Memorandum

Subject: Destinations DRI #2574 Correction of Transportation Analysis Report Graphics

Figure 6 – Existing Lane Configuration and Traffic Control

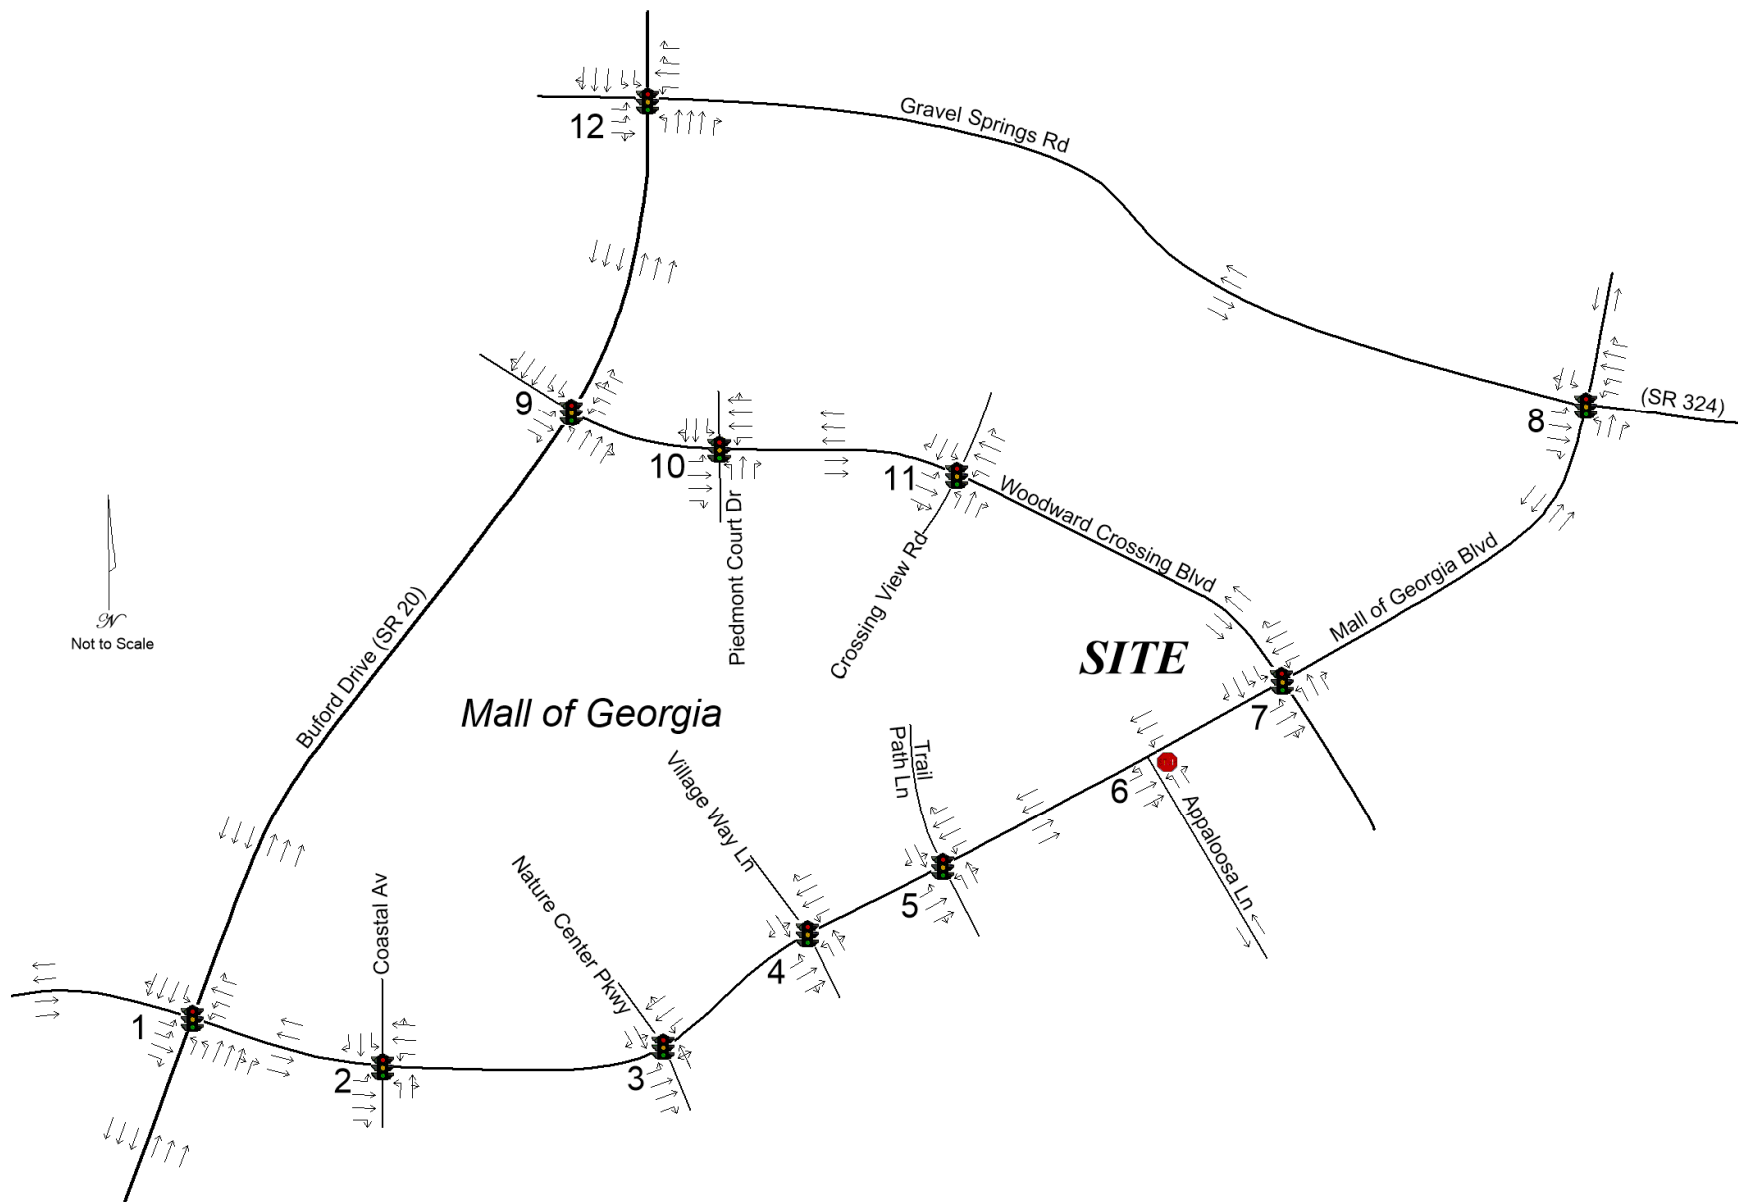
In the lane configuration graphics in the Transportation Analysis for Destinations Multi-Use Development, DRI #2574, it was identified that the lane configuration presented at intersections #8 – Gravel Springs Road at Mall of Georgia Boulevard, #9 – Buford Drive at Woodward Crossing Boulevard, and #10 – Woodward Crossing Boulevard at Piedmont Court Drive, contained minor errors. The affected graphics are found in Figure 6 – Existing Lane Configuration and Traffic Control and Figure 14 – Summary of Mitigation. The corrected graphics are presented on the next two pages of this memorandum, and supersede those corresponding figures in the report.

It was verified that the correct lane configurations were used in the Synchro intersection analysis and that the errors were limited to the two graphics.
